# Spartan Motors Chassis, Inc.

SERVICE BULLETIN

TSB13-500-001

- SUBJECT:** Air springs may not inflate before moving the motor home.
- CONDITION:** During low voltage conditions, the Interface Module may not activate the Hadley Air Level system module.
- APPLIES TO:** This bulletin applies to K2 and K3 model motorhome chassis assembled by Spartan Motors Chassis, Inc. between January 4, 2007 and June 26, 2013.
- CORRECTION:** Change the constant battery circuit of the module to a switched power source. In this case the accessory circuit will be used.
- LABOR ALLOCATION:** .5 hrs.

**FIG. 3-1**

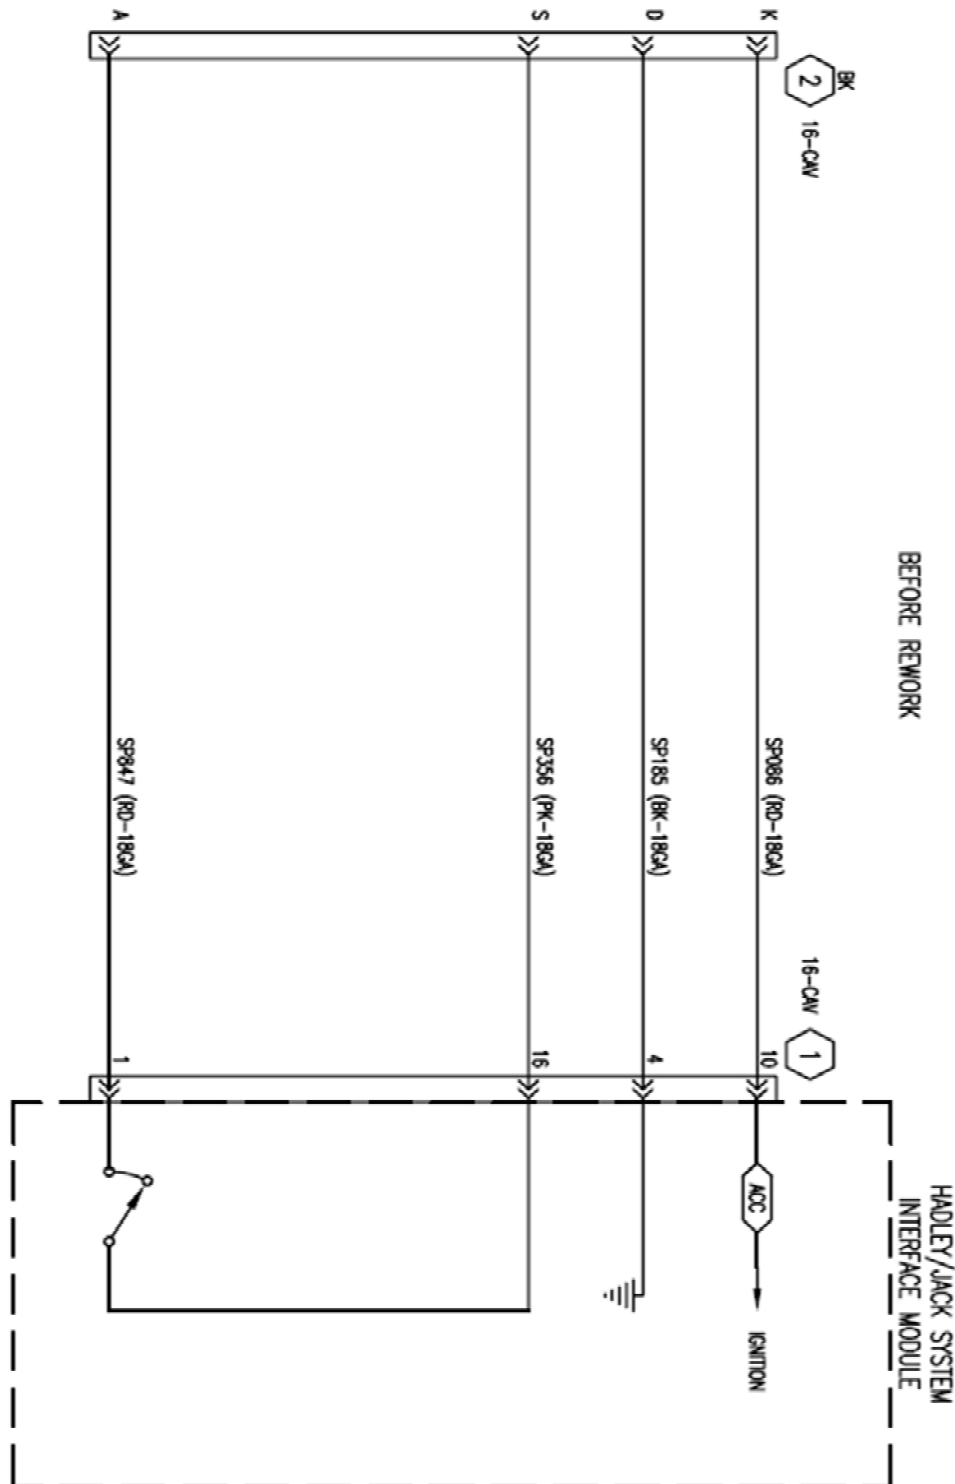
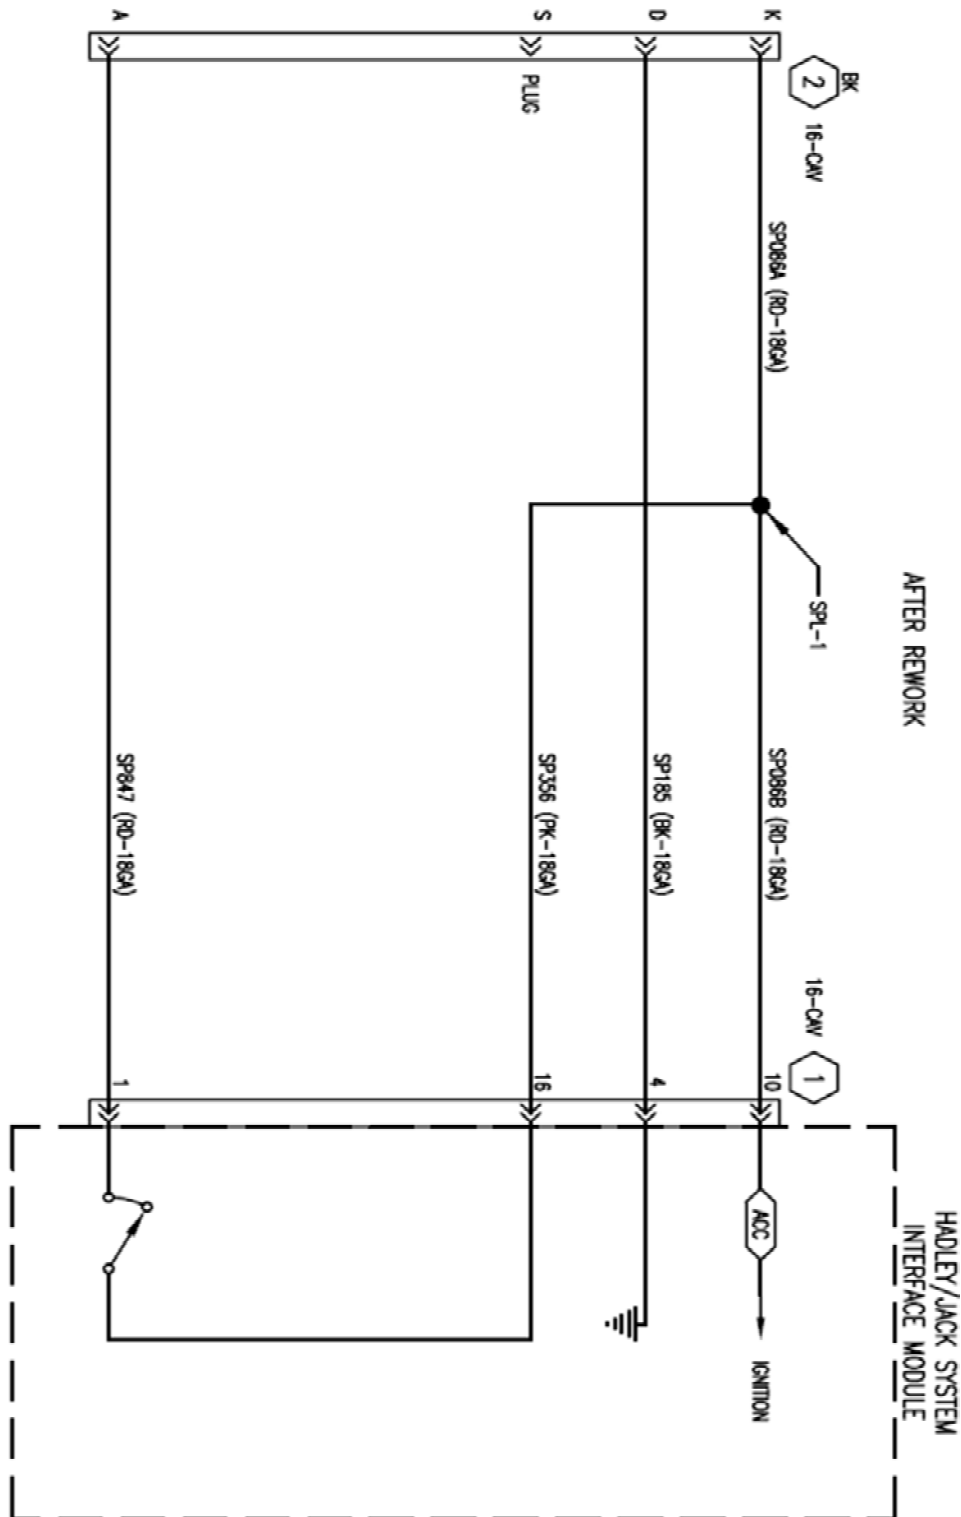
3. Remove wire SP356 (pink) from cavity “S” and remove wire SP086 (red) from cavity “K”.  
Removing wires from the GT-280 Series Connectors:
  - a. Gently pry up both sides of the purple Terminal Position Assurance (TPA) and set aside.
  - b. Using a Delphi depinning tool (12094429) or similar, gently pry the lock away from the terminal with one hand and with the other hand, gently pull the wire and terminal from the connector.
4. Install supplied cavity plug into cavity “S”.

5. Splice together wires SP356 and SP086 by soldering and applying heat shrink to the solder joint.

6. Reinsert SP086 back into cavity “K”.

7. Refer to FIG. 3-1 and 4-1 below, for a schematic of “before rework” and “after rework”.
